Proposal for Constellation Re-arrangement in IR HARQ

IEEE C802.16m-09/0124r1

Target section: 11.13.2.2 Bit re-arrangement

Problem of Current Co-Re Operation

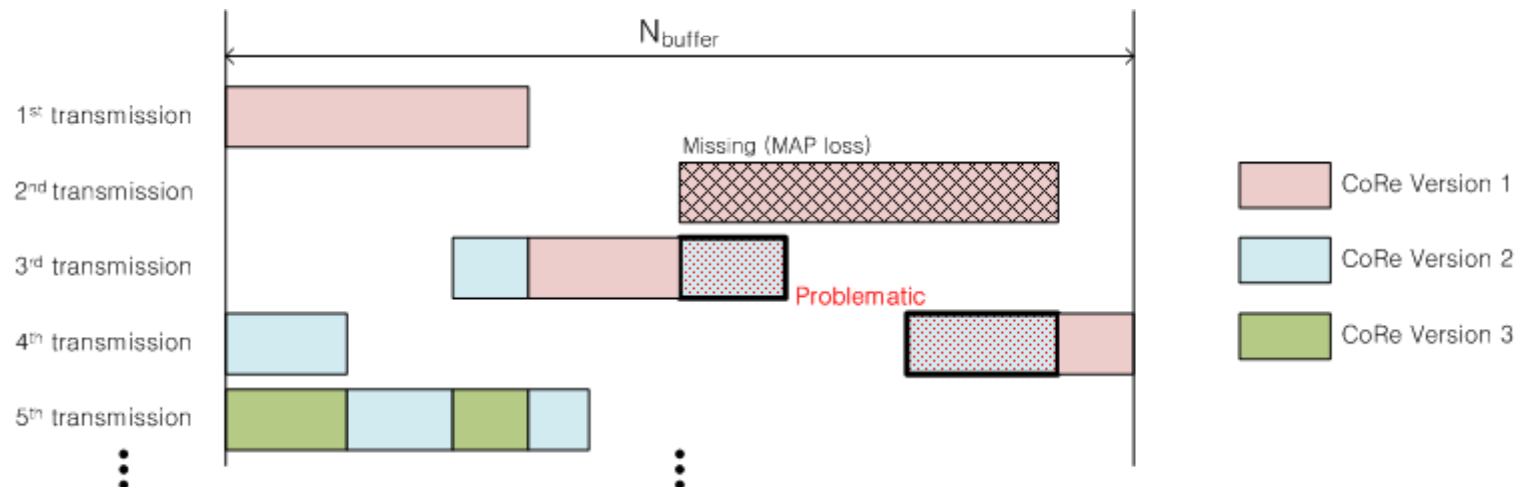
- Current Co-Re operation has a problem in case of IR-HARQ and adaptive HARQ.
 - If the MAP is missing, the MS can't know the CoRe-version for each transmitted bit.
 - In IR and adaptive HARQ operation, this problem is critical.
 - For each transmitted symbol, the CoRe-version may be indicated, but the overhead is large.

Proposed Co-Re Operation

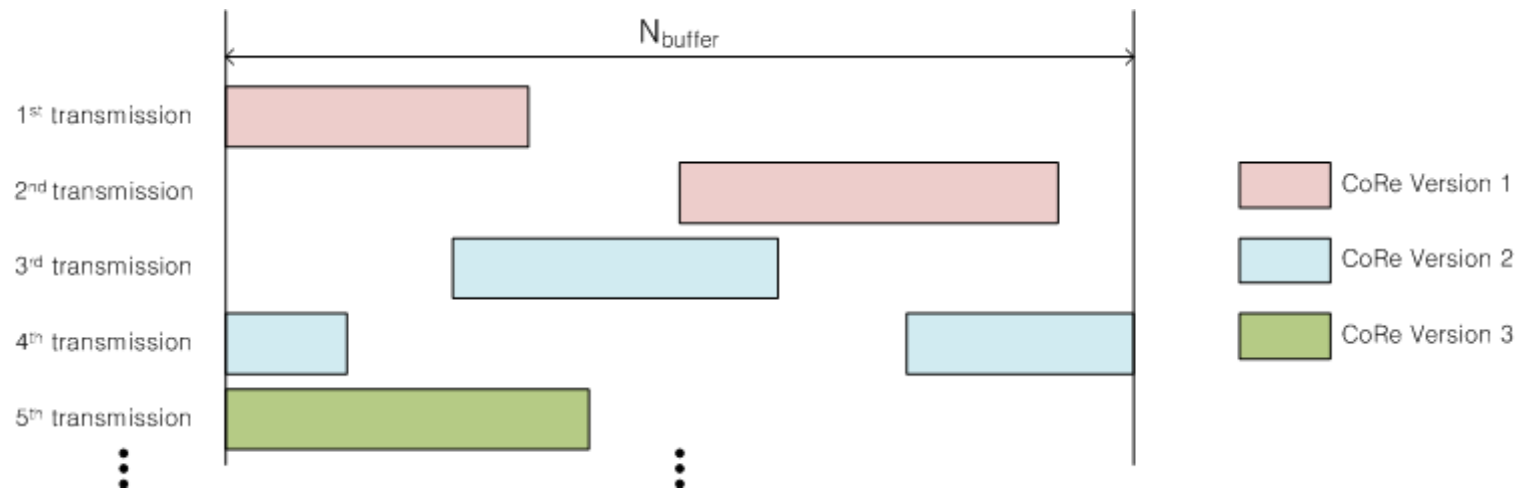
- In the proposed scheme, all the modulated symbols in a HARQ re-transmission use same CoRe-version.
 - Robust Co-Re operation in case of MAP loss
 - Minimal overhead for CoRe operation

~~Bit re-arrangement (BitRe)~~Constellation re-arrangement (Co-Re) is supported in 802.16m. ~~Bit re-arrangement includes a bit-level interleaver and an inverter. For each transmitted burst, the BitRe version is selected by the transmission number.~~ The Co-Re can be expressed by a bit-level interleaver within a QAM symbol. All the QAM symbols in the same HARQ re-transmission use same Co-Re version. The specific ~~bit-level interleaver and inverter~~ selection mechanism is FFS.
